**Environmental Assessment for U.S. Army Corps of
Engineers Land Exchange of Properties at Artificial
Island, Salem County, New Jersey for Properties in
Oldmans Township, Salem County and Logan
Township, Gloucester County, New Jersey;
Development of Confined Disposal Facility**

**U. S. Army Corps of Engineers
Philadelphia District
Wanamaker Building, Room 643
100 Penn Square East
Philadelphia, PA 19107-3390**

January 2015

Figure 4 - Design of CDF at Site 15G

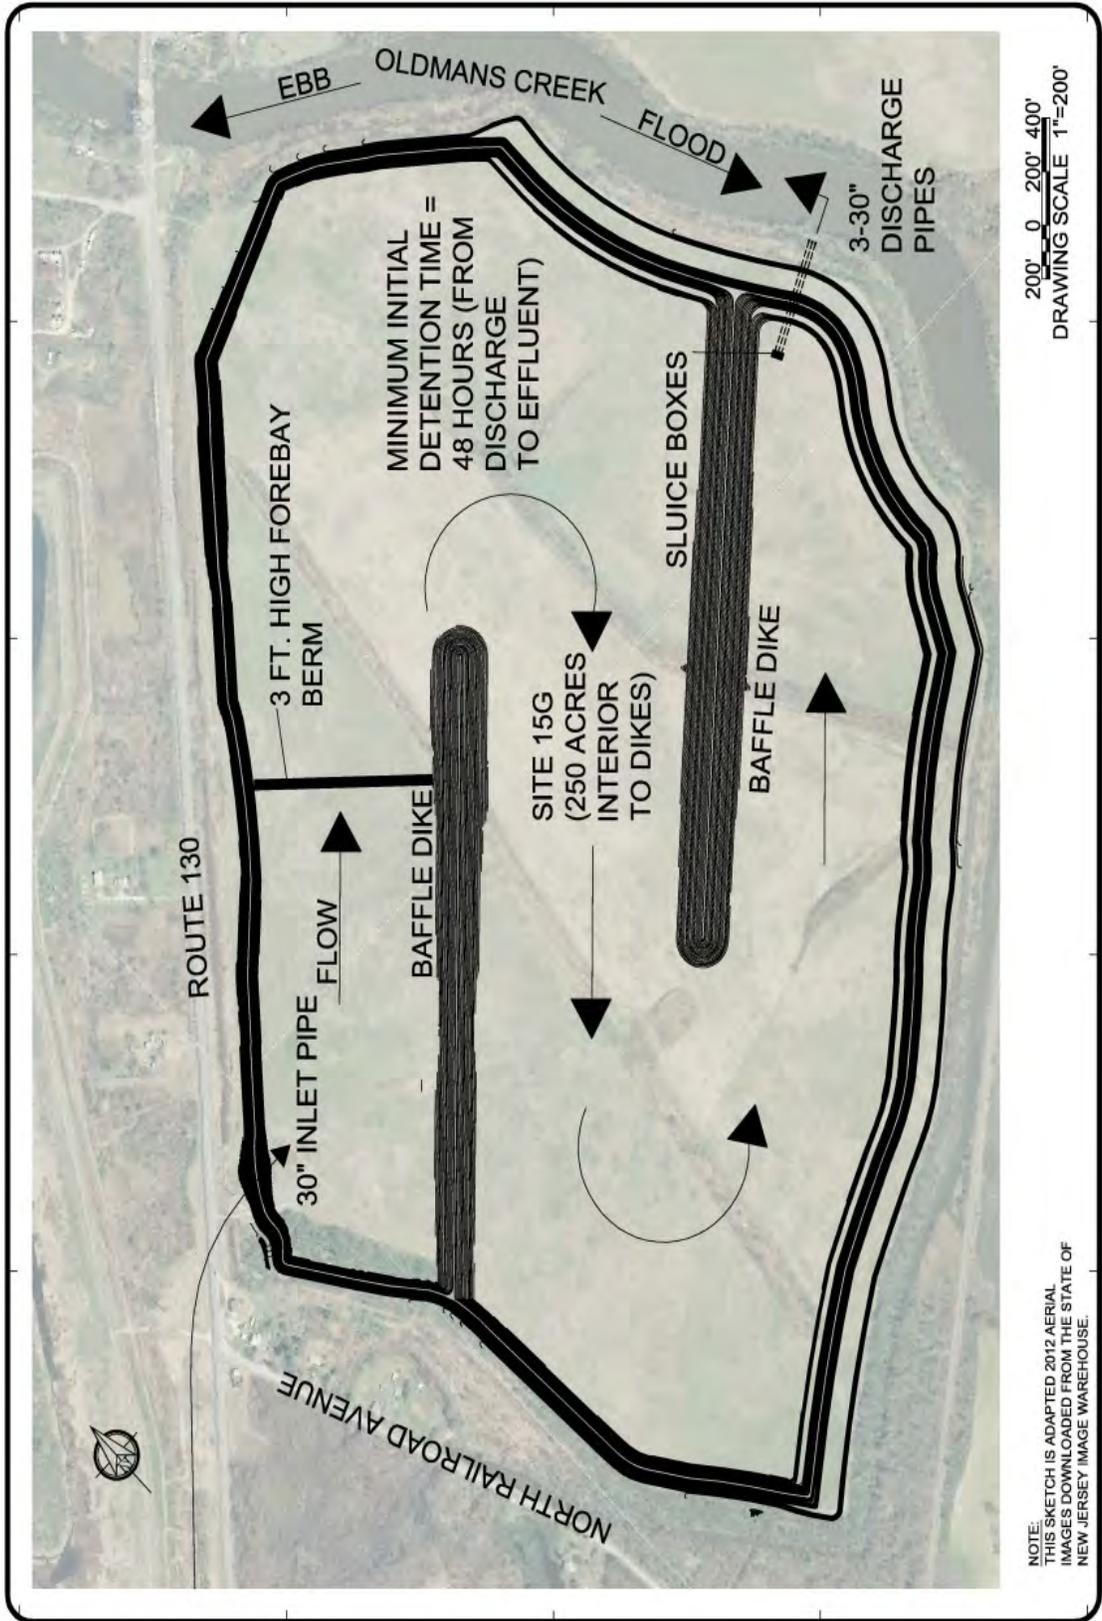
- (6) Section 3.2.2.1, page 11, para. #4 and Figure 4: the NJ Department of Transportation will have to approve the installation of the dredged material inflow pipe under Route 130.
